720 ERBSVILLE ROAD, WATERLOO, ON
ENVIRONMENTAL NOISE STUDY
REVISED SITE PLAN

NOISE PLAN OVERLAY WITH SITE PLAN

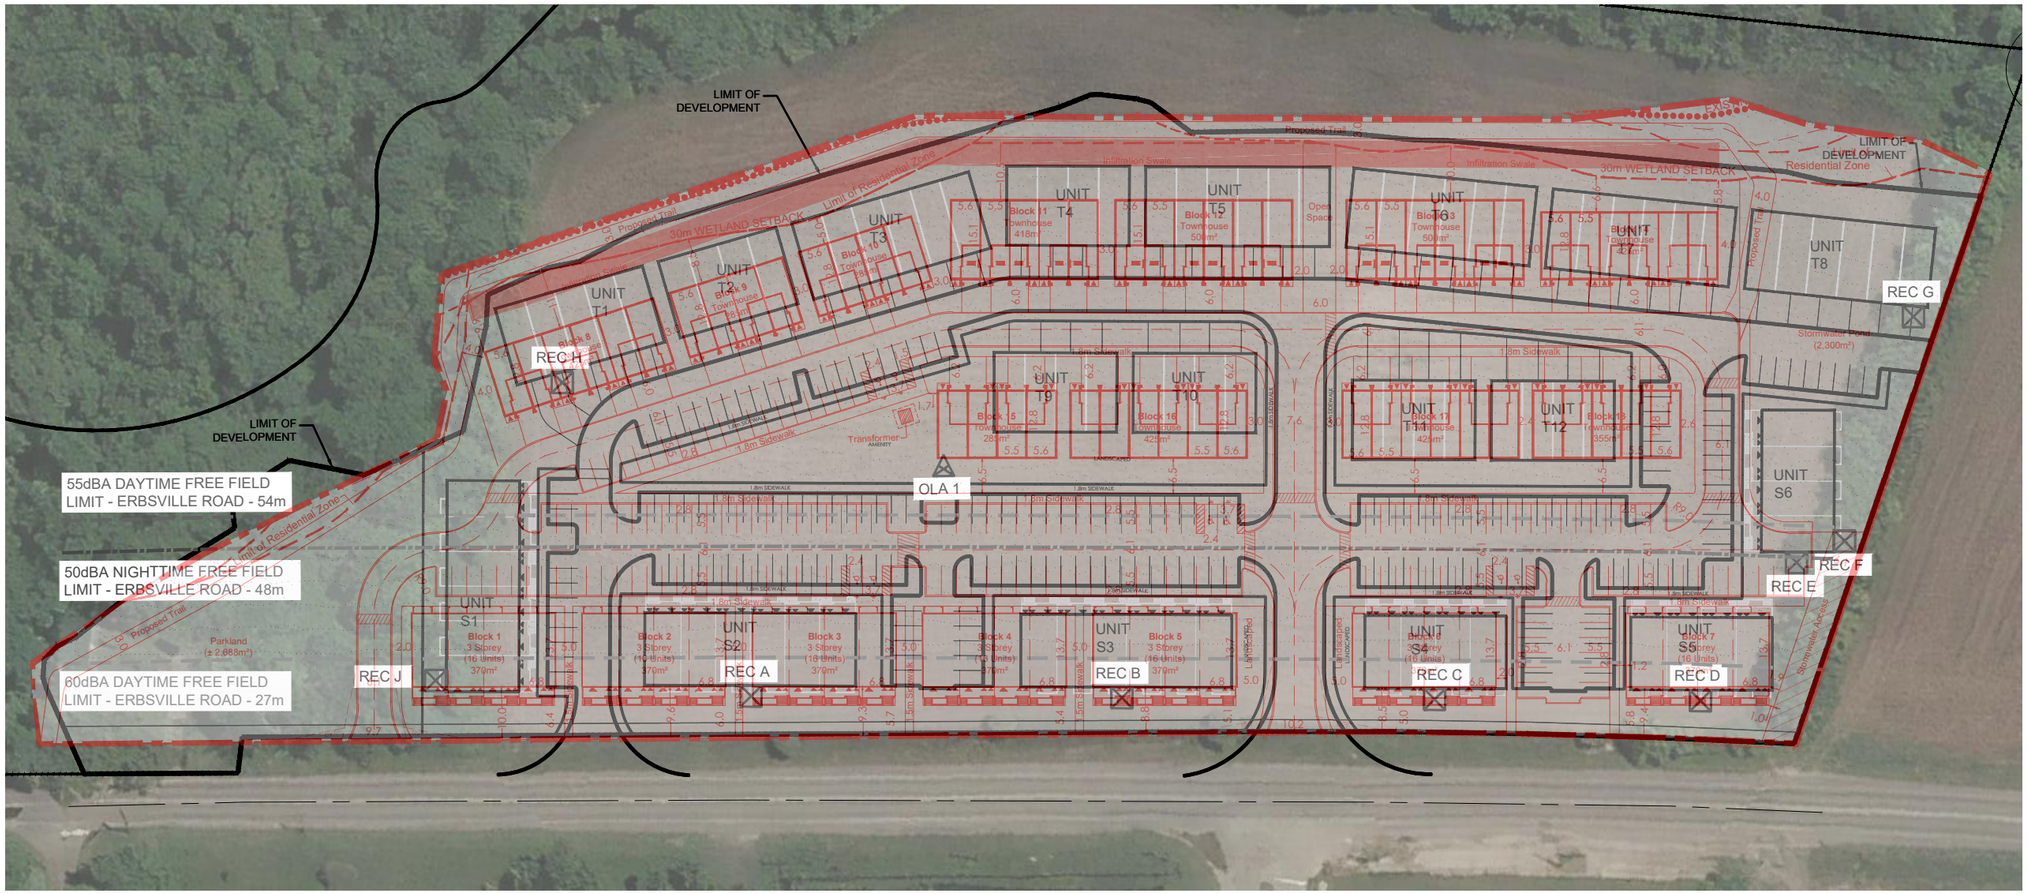
Subsequent to the October 2021 Noise Study, the proposed development's Site Plan has been modified. We have overlaid the current Site Plan (February 10, 2025) onto IBI's October 2021 Noise Information plan as attached. The red linework and text represent the current Site Plan, and the black lines and text, and aerial photo represents the October 2021 Site Plan. From this comparison, we make the following observations:

1. The setbacks from Erbsville Road (the noise source) to the adjacent critical (most exposed) residential receivers has not significantly changed for many (i.e., Receivers A, B, C, D and J). Thus, the noise levels for the receivers on the revised Site Plan will remain unchanged from that reported in the October 2021 study.

2. The setback from Erbsville Road (the noise source) to the development's outdoor amenity area (i.e., OLA 1) has not significantly changed and thus the noise level will be the same.

3. The buildings flanking Erbsville Road provide a partial barrier for noise to the interior of the development. While the IBI study did not account for this screening of noise, it is noted that the building flankage has increased from 57% to 69% of the residential frontage (not including the Parkland Block). Thus, the revised Site Plan will generally have reduced noise levels at the interior receivers compared with the October 2021 Site Plan.

Accordingly, we conclude that the analysis and findings of the October 2021 Noise Report remain valid for the revised Site Plan, and that the Report's recommendations remain unchanged for the revised Site Plan.

We recommend that a revised Noise Report is not needed at this functional stage of the development's planning and design. If required, a final Noise Study could be prepared during the Site Plan Approval stage of the project to ensure no other noise mitigation is warranted.
